DISABILITY AND COMMUNICATION ACCESS BOARD

SITE SPECIFIC ALTERNATE DESIGN

Docket: **SSAD 2009-02:** Request for the site specific alternate design to depart from the running slope requirement of the Americans with Disabilities Act Accessibility Guidelines Section 4.3.7 Slope by applying the Architectural Barriers Act Accessibility Guidelines for Outdoor Developed Areas dated June 20, 2007 to the Kawaihau Connection of the Lydgate-Kapa'a Bicycle & Pedestrian Path.

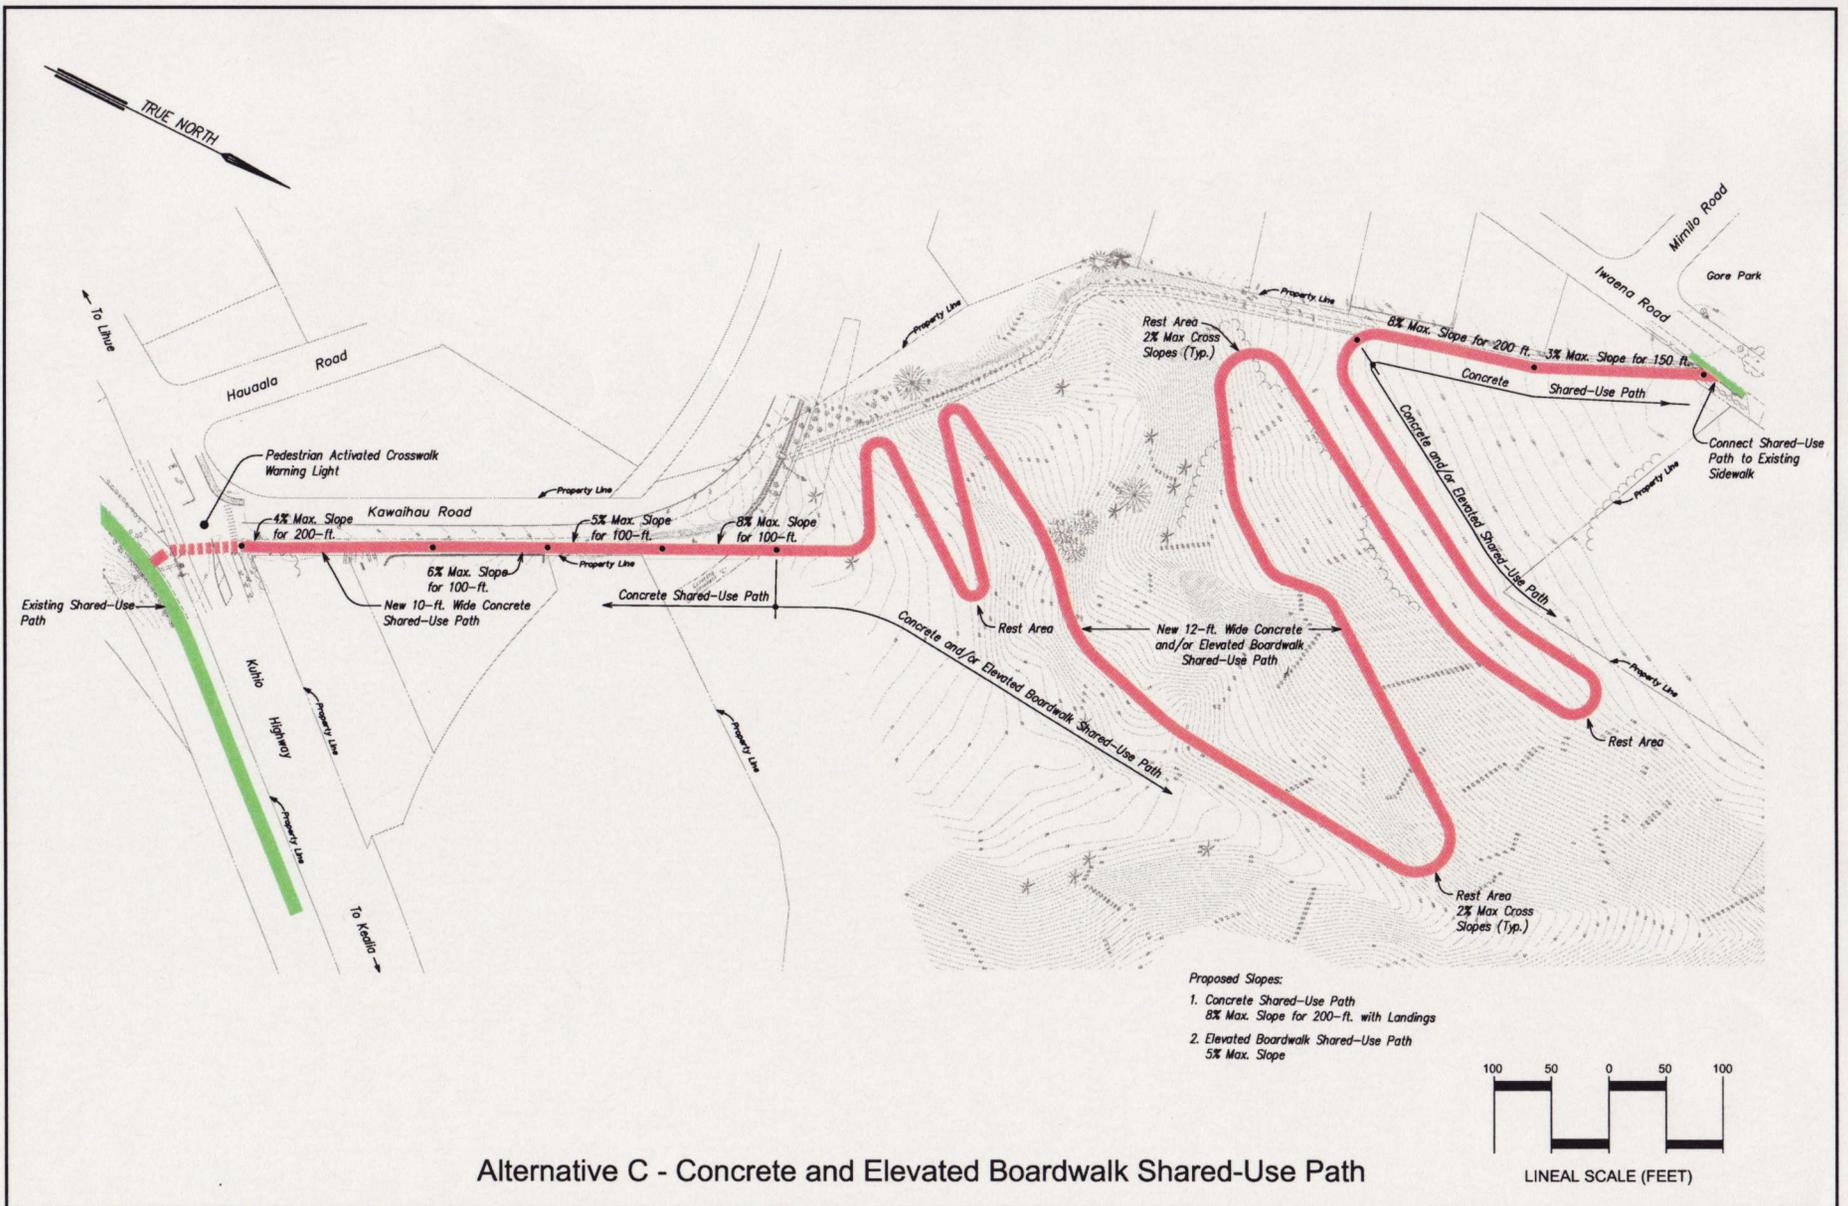
Summary: The Kawaihau Connection extends from the Lydgate-Kapa'a Bicycle & Pedestrian Path near the Kuhio Highway/Kawaihau Road Intersection to Iwaena Road near Mimilo Road. The Kawaihau Connection is intended to provide a safe bicycle and pedestrian path from the neighborhood surrounding Kapa'a High and Elementary School to the Lydgate-Kapa'a Bicycle & Pedestrian Path and surrounding natural resources. Due to the existing terrain, portions of the Kawaihau Connection exceed 5% running slope. Instead of providing an accessible route that complies with the ADAAG running slope requirements, the proposed alternate design provides a concrete shared-use path with an 8% maximum running slope and landings every 200 feet. A portion of the path may be a raised boardwalk with a 5% maximum running slope. The County of Kauai considers the path a shared use path and not an accessible route. In addition, the Federal Highways Administration (FHWA) considers the Kawaihau Connection a shared use path, where it is not within the public right-of-way. The appropriate design guideline for this portion is the U.S. Access Board's Regulatory Negotiation Committee on Accessibility for Outdoor Developed Areas Final Report. The FHWA considers the portion of the Kawaihau Connection within the public right-of-way a sidewalk, which is subject to sidewalk design guidelines.

The Kawaihau Connection of the Lydgate-Kapa'a Bicycle and Pedestrian Path must comply with the Americans with Disabilities Act Accessibility Guidelines, where the Kawaihau Connection is within the public right-of-way. The Kawaihau Connection of the Lydgate-Kapa'a Bicycle and Pedestrian Path may comply with the Architectural Barriers Act Accessibility Guidelines for Outdoor Developed Areas Section T303.8.2 Running Slope dated June 20, 2007 in lieu of complying with the running slope requirements of the Americans with Disabilities Act Accessibility Guidelines Section 4.3.7 Slopes, where the Kawaihau Connection is not within the public right-of-way.
